CLIENT: METRO PROPERTY DEVELOPMENT  
PROJECT: CENTRAL VILLAGE STAGE 4 AND 5  
ADDRESS: CORNER OF WATER AND BRUNSWICK STREET

DRAWING TITLE  
SITE PLAN EXISTING/DEMOLITION

PLANS AND DOCUMENTS  
referred to in the PDA APPROVAL

1 LEVEL 1 STAGING  
30.01 1:500

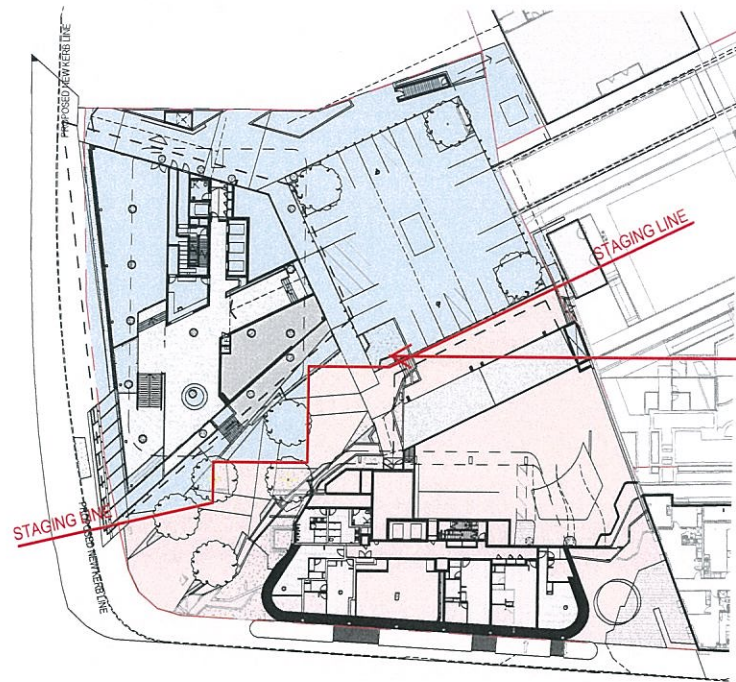
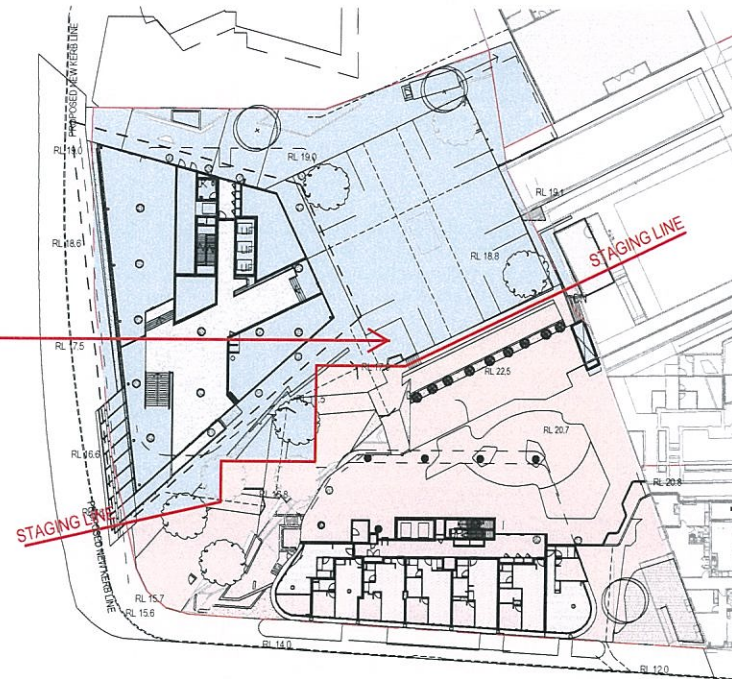
NOTE: PEDESTRIAN LINK STRUCTURAL SLAB TO BE CONSTRUCTED IN STAGE 4 ONLY TO EXTENT SHOWN. STAGE 5 TO INCLUDE REMAINING PEDESTRIAN LINK STRUCTURAL SLAB AND ALL PEDESTRIAN LINK EXTERNAL FINISHES

NOTE: BASEMENT MECHANICAL EXHAUST (SHOWN BLUE) TO BE CONSTRUCTED IN STAGE 4 WORKS

NOTE: BASEMENT MECHANICAL EXHAUST (SHOWN BLUE) TO BE CONSTRUCTED IN STAGE 4 WORKS

AMENDED IN RED

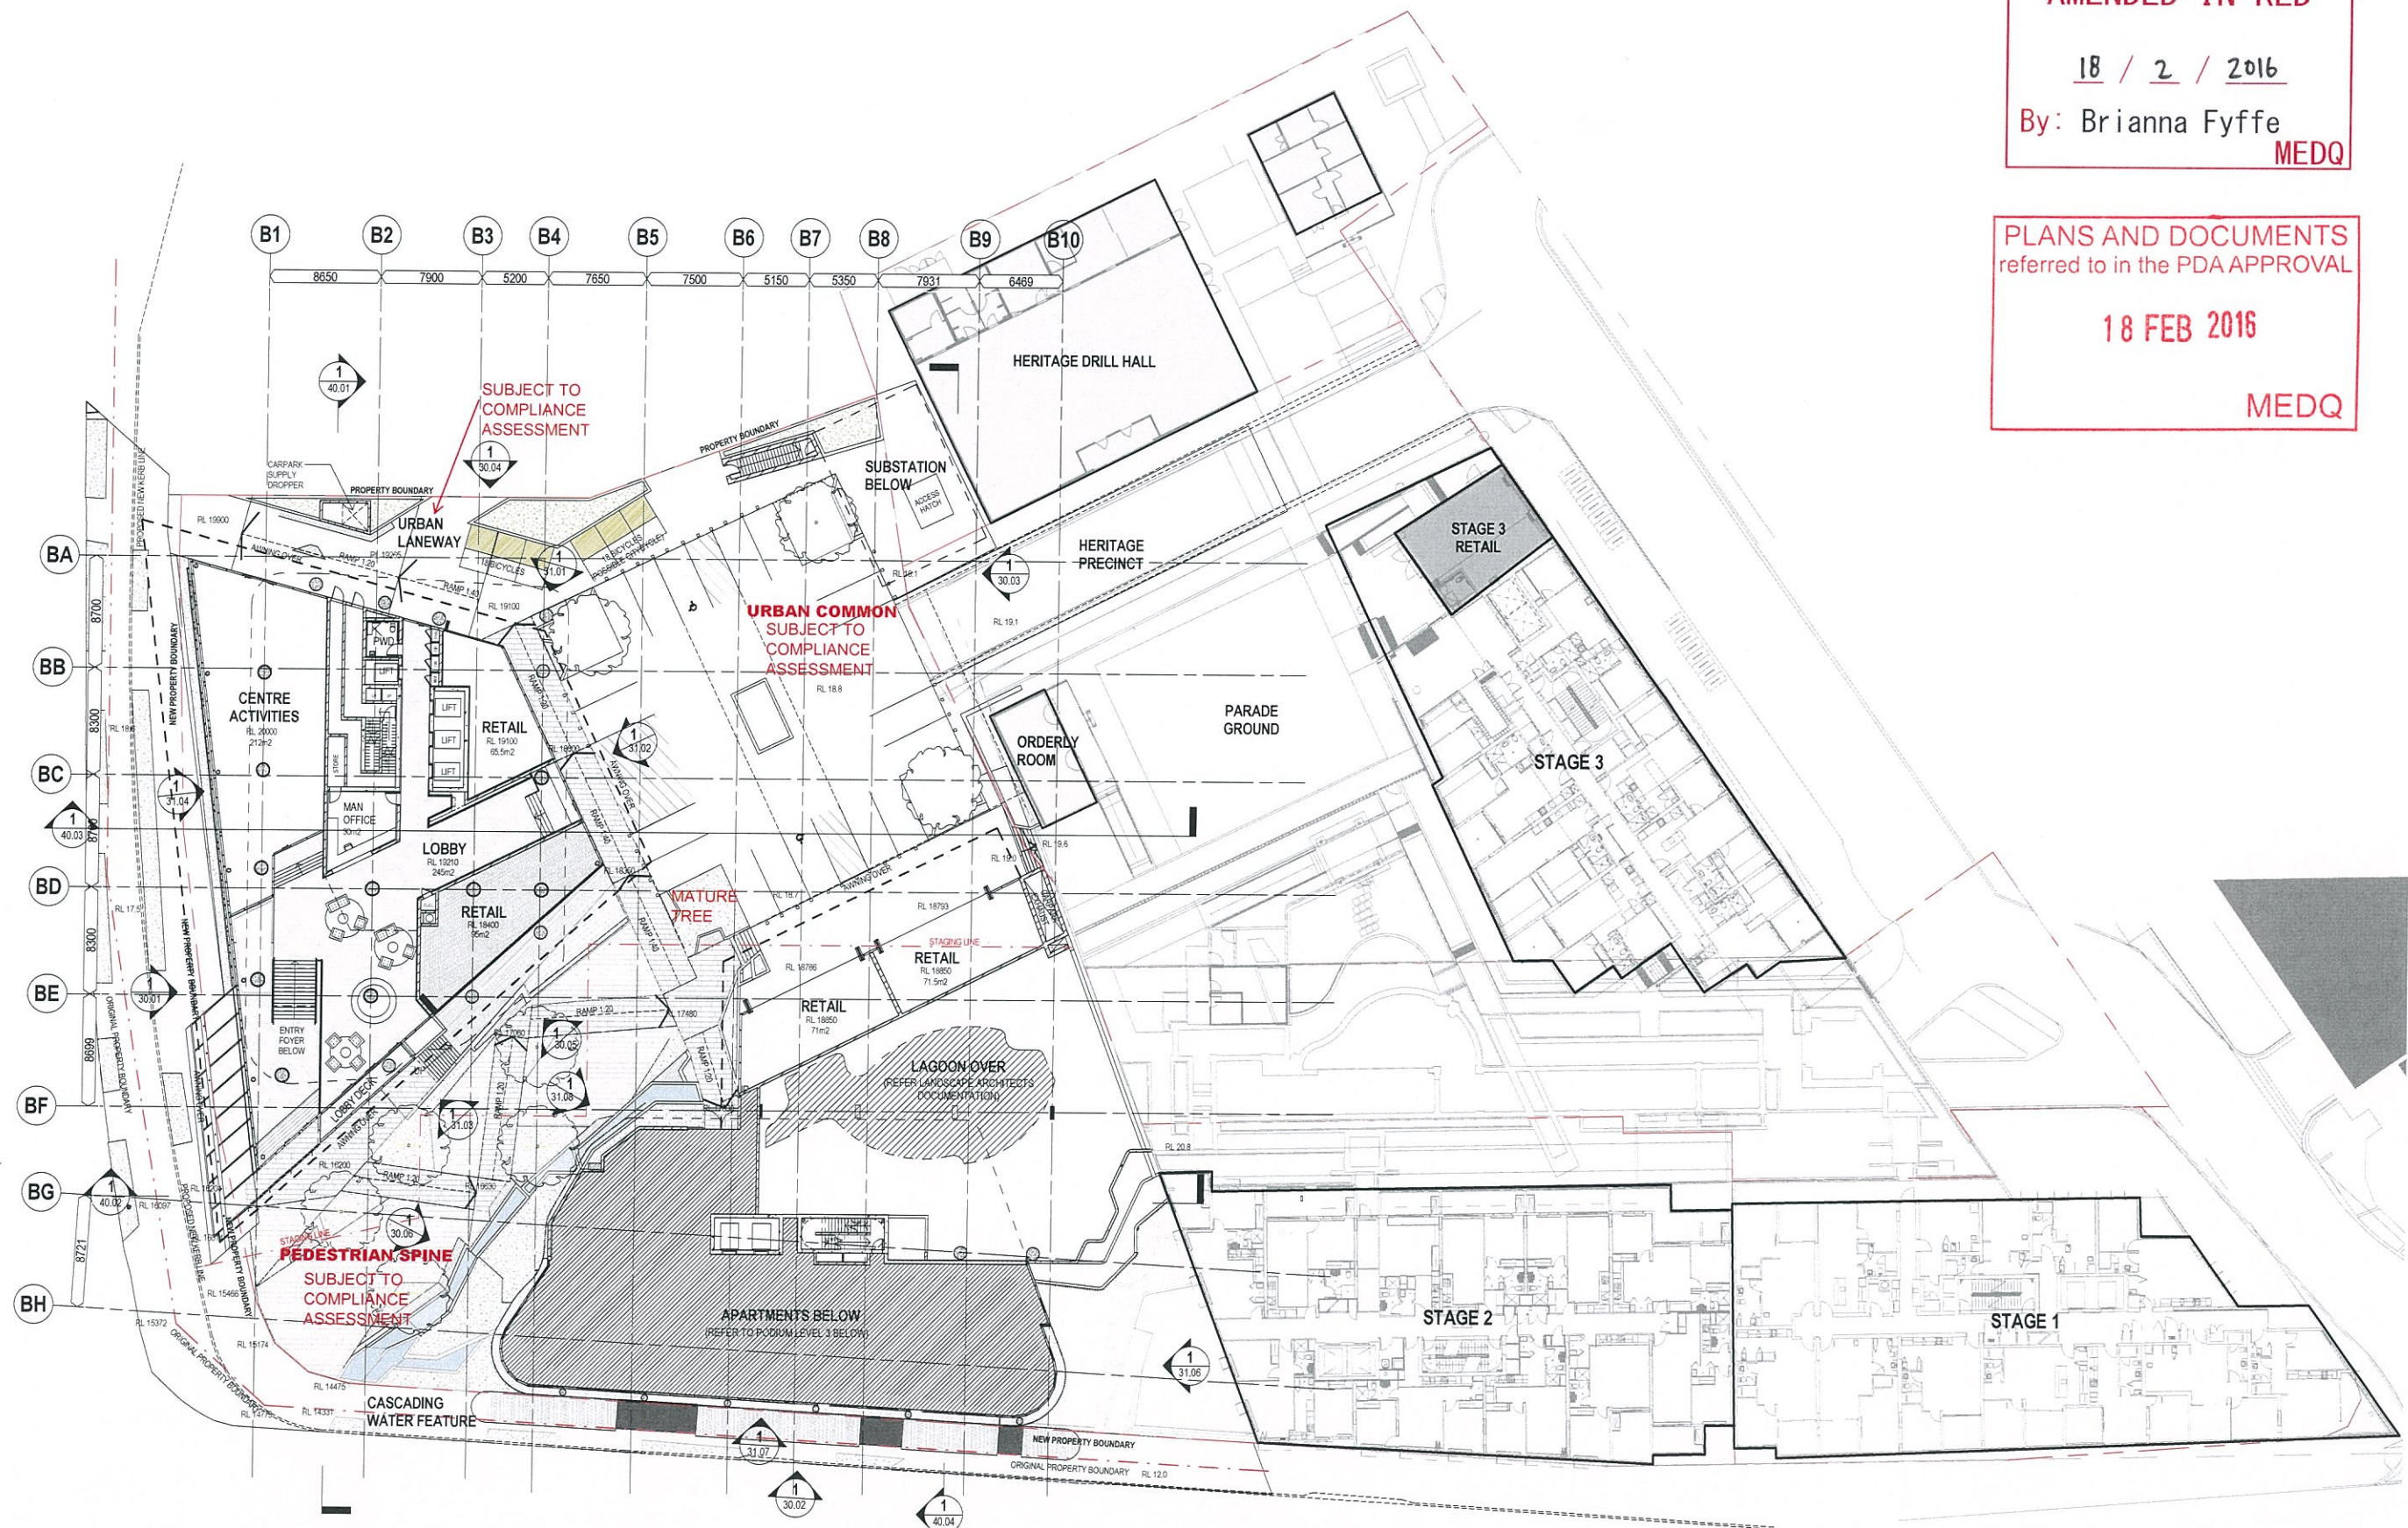
AMENDED IN RED

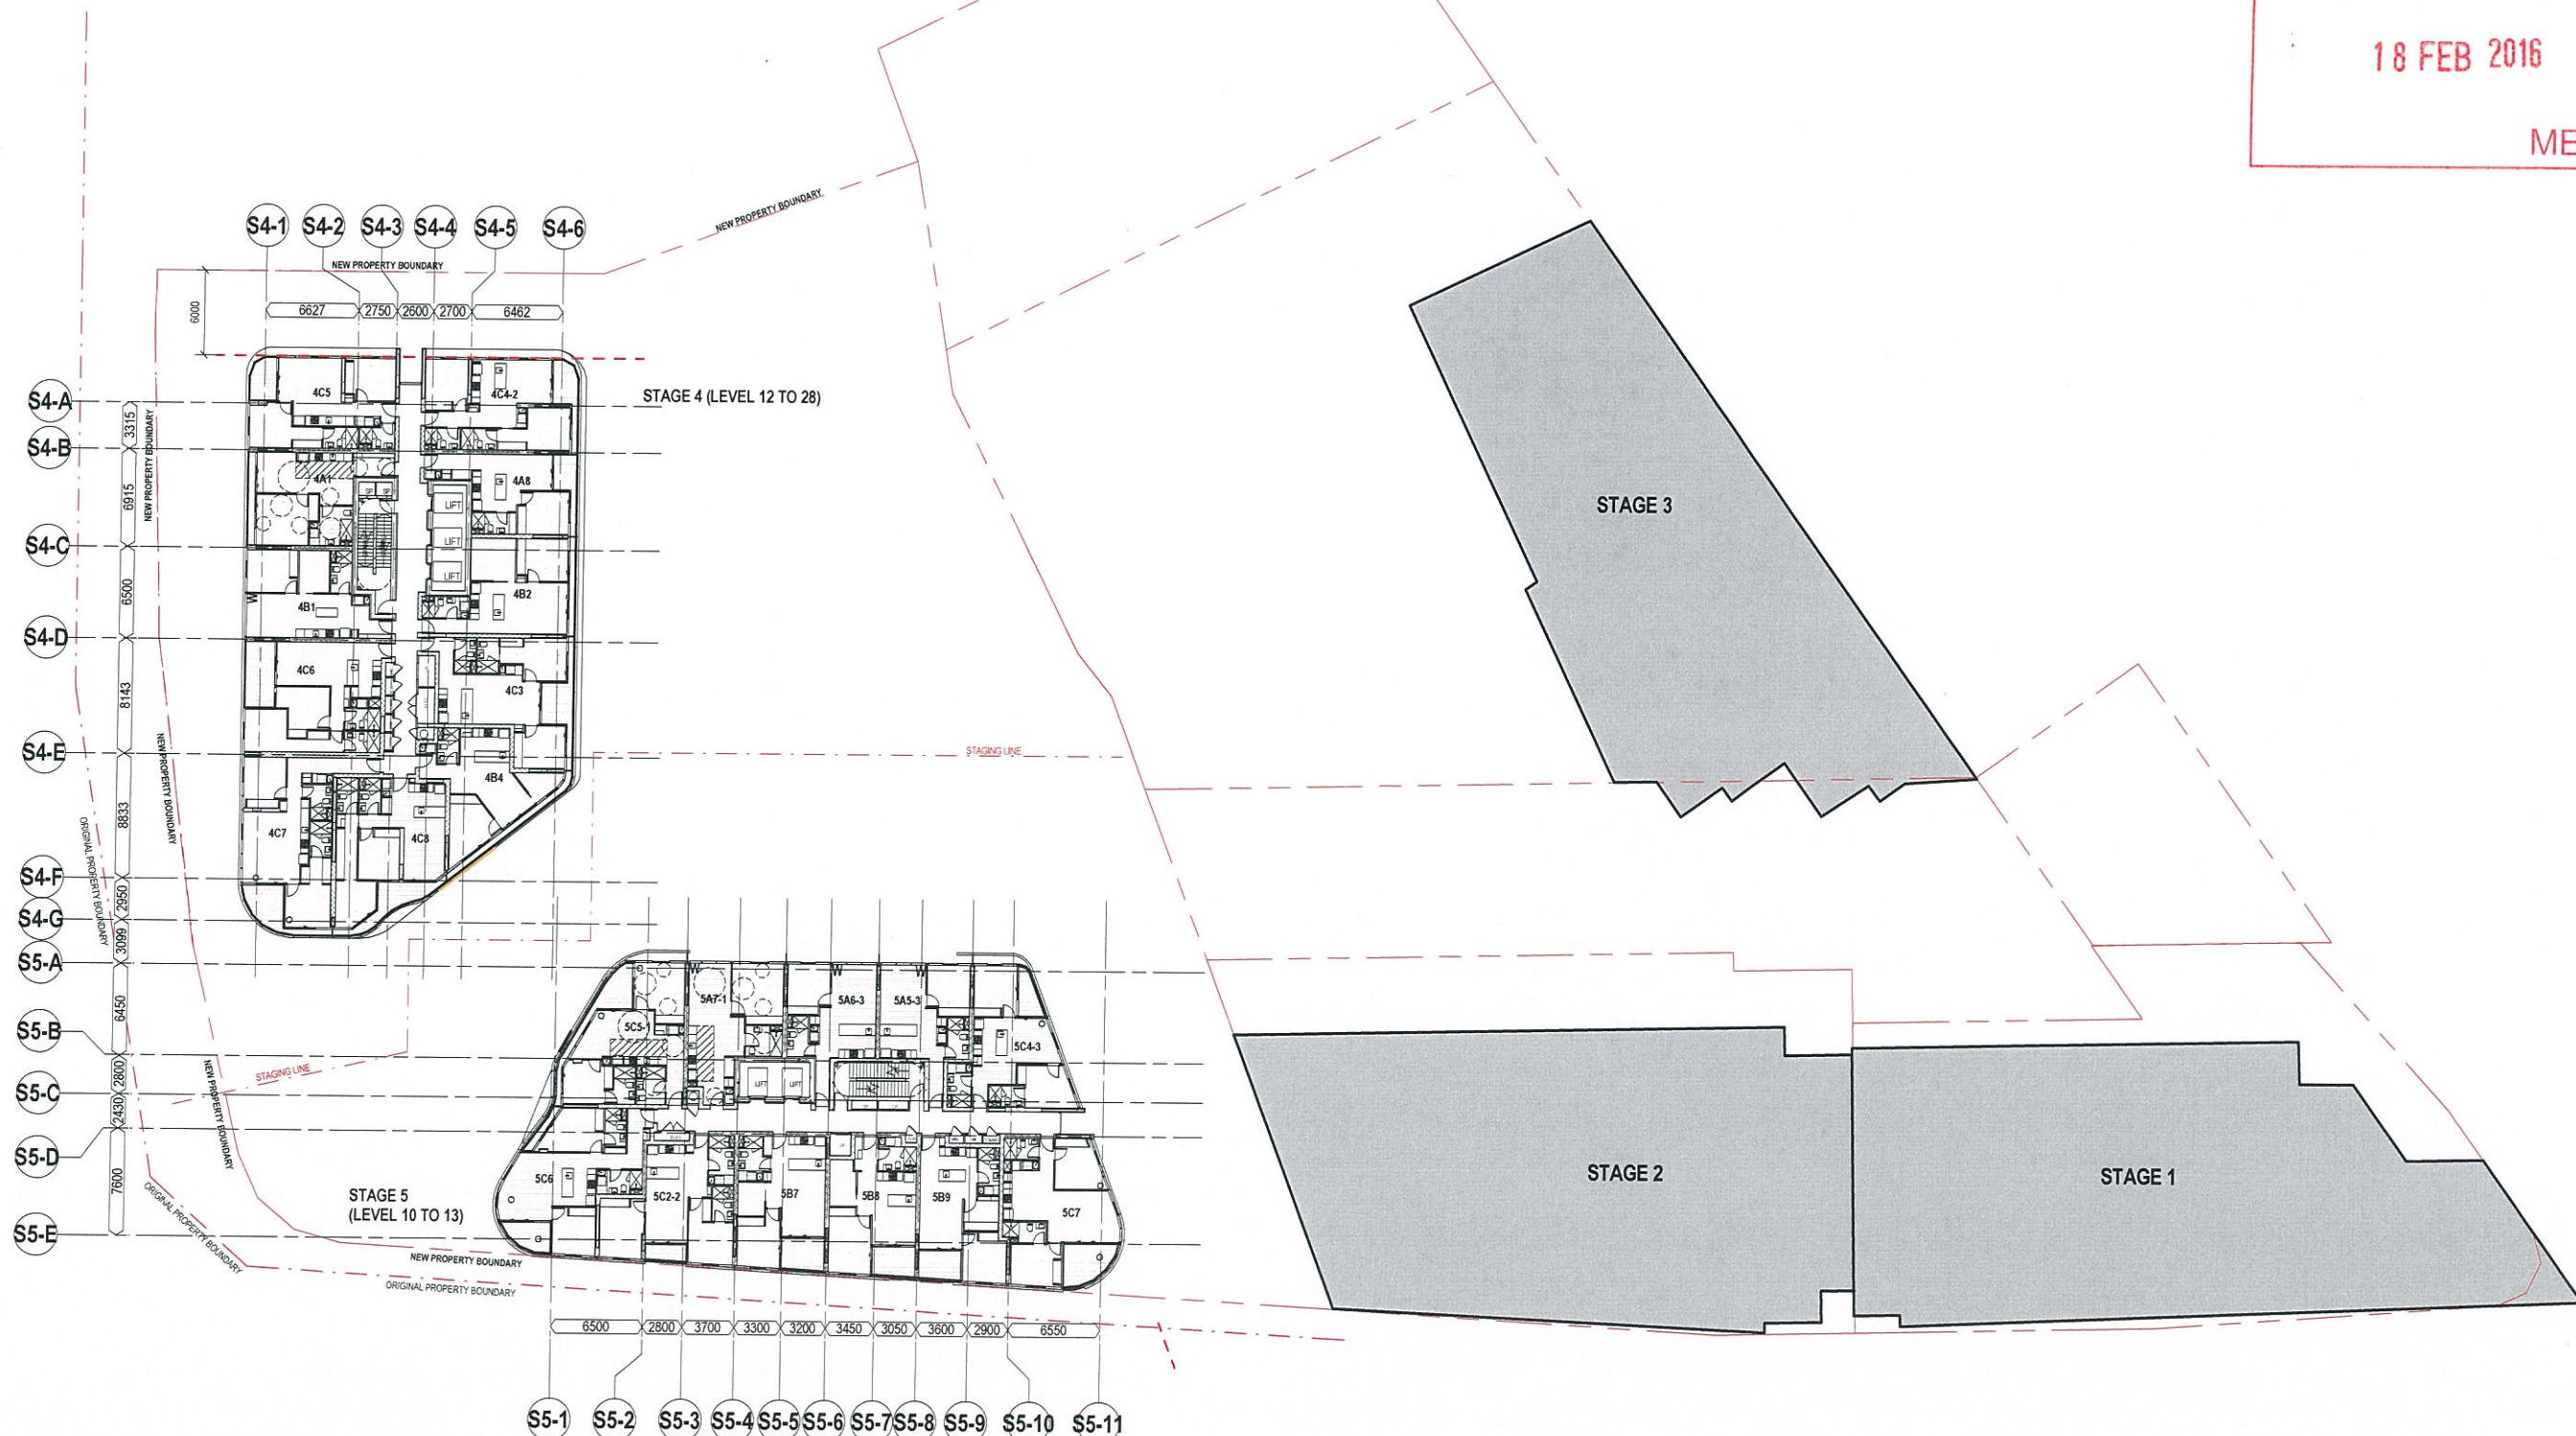
AMENDED IN RED

| DRAWING TITLE  |            | KEY PLAN - LEVEL 12-28 (Stage 4)<br>Level 10-13 (Stage 5) |            |

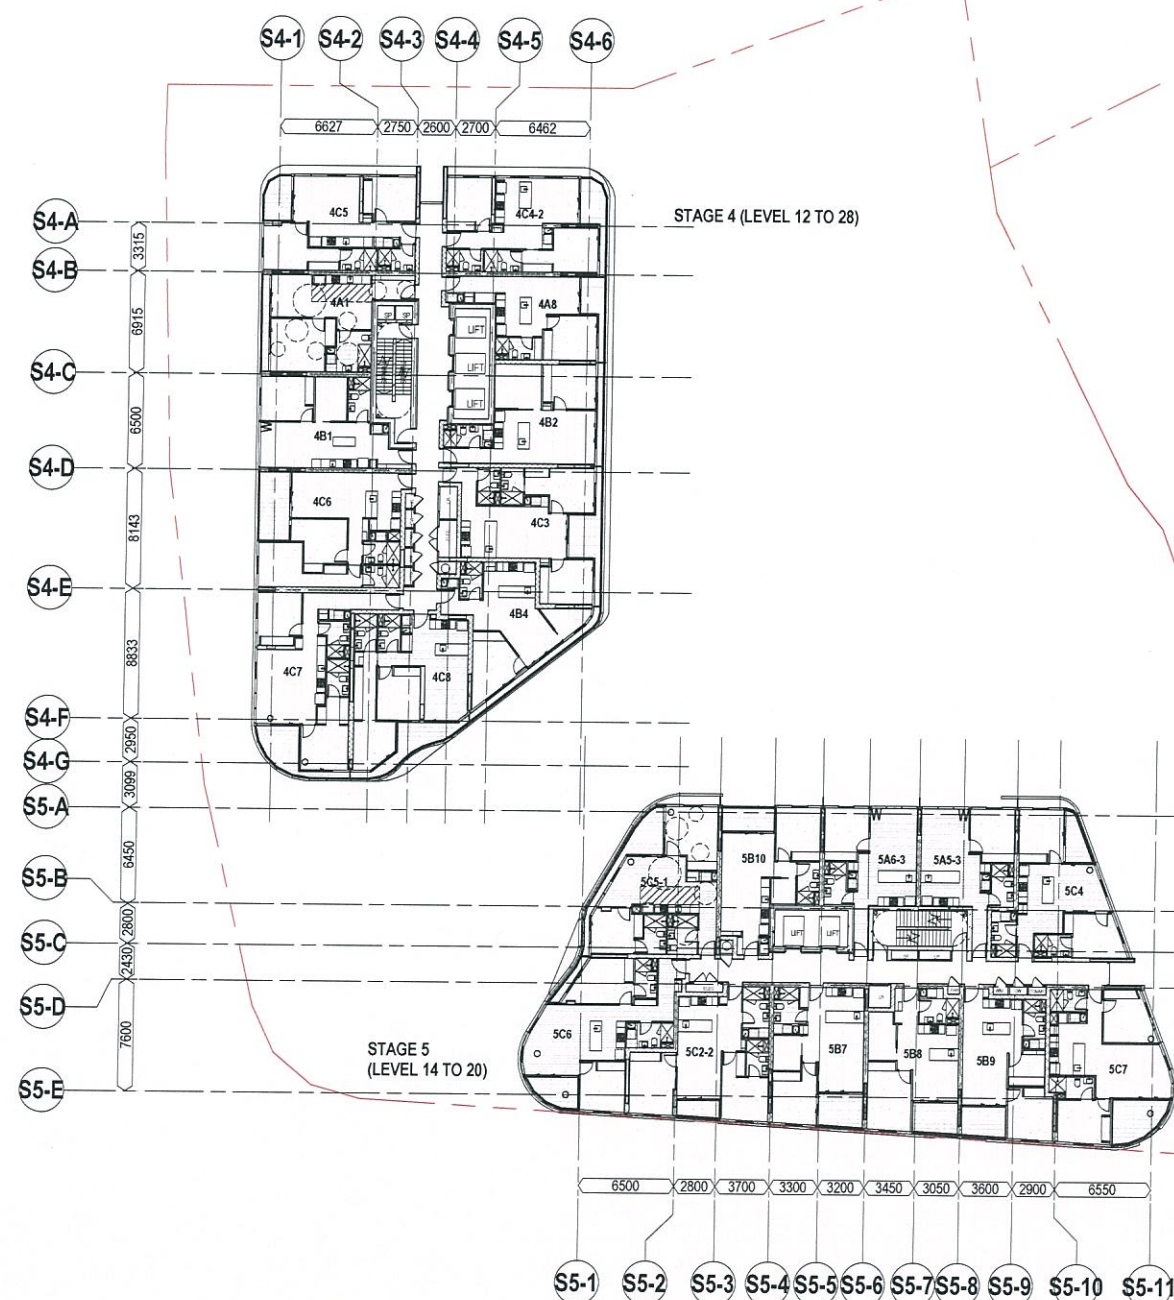
AMENDED IN RED
